DISPLAY THIS CARD ON PRINCIPAL FRONTAGE OF WORK CITY OF PORTLAND

PERIVITION Permit Number: 070360

has permission to _____Replace dining room & Decl

RE: 493 Ocean Avenue – 163-D-003 – R-5 primary zone along Ocean Ave, with R-3 zone in the rear – permit #07-0360

REMODELED SECOND FLOOR

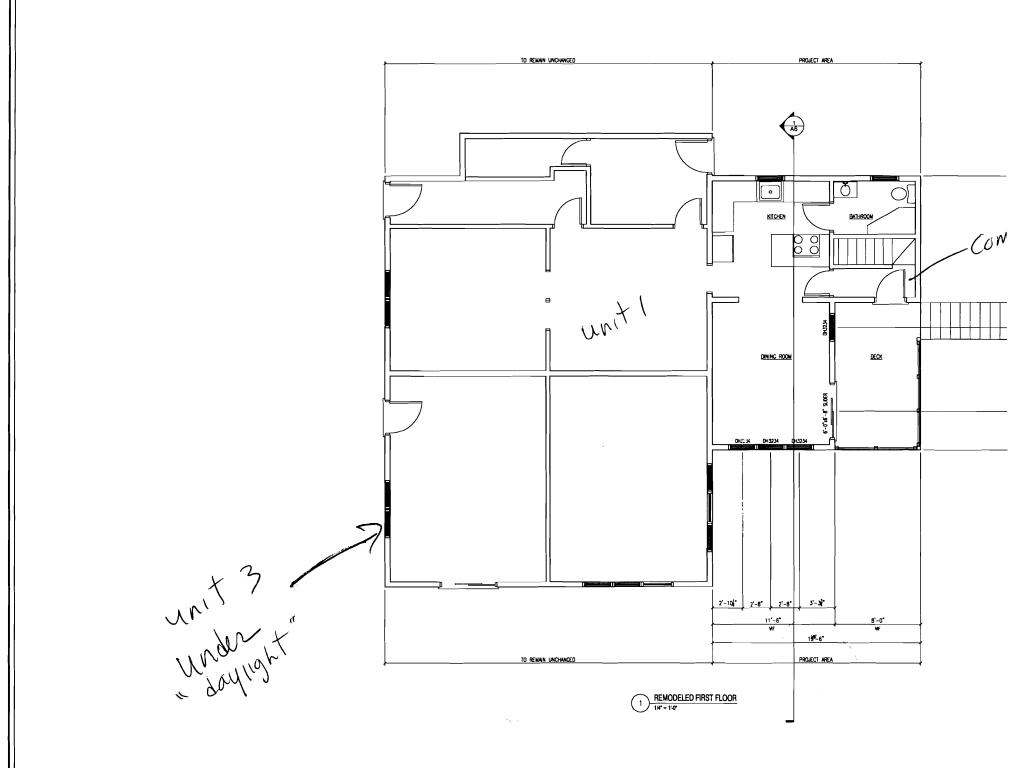
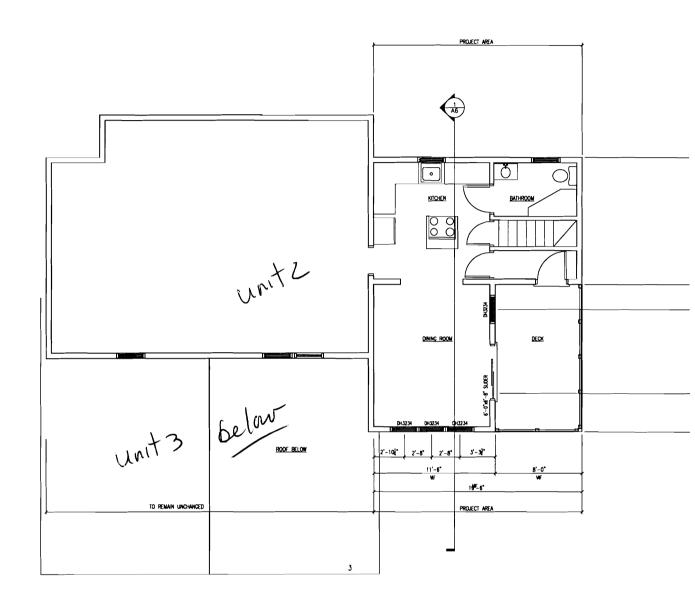
1/4/2008-mes: met with Mr. Johnson - he showed me some sketches that could work. The sketches were not scalable and wasn't able to be sure that it was meeting the 14-436, but it looks closer. I wanted some scalable plans and floor to ceiling heights for the "attic" area above.

4/1/2008-jmb: Spoke to Scott T. About details on plans, new framing section, floor ceiling assemblies, penetrations, storage area separation, stair construction and railings, all on a scale large enough to read. He will submit.

5/2/2008-jmb: Spoke to Scott J. The plans still don't include the fire/sound rated floor ceiling assemblies, stair details and fire penetration. He will submit. He also said the pdf was emailed to Lannie.

5/12/2008-jmb: Email msg to Scott J. After receiving the plans for the stairs: I am going allow use of the IRC code for the stair construction as the 3rd unit is independent from the 1st and 2nd units.

This means that the stair and deck guard must be a minimum of 36" in height instead of 42". The handrail height on the stairs can be between 34"-38" as stated on the plans, if it is mounted separately from the top of the balustered rail, or the graspbable handrail can be the top rail at 36".
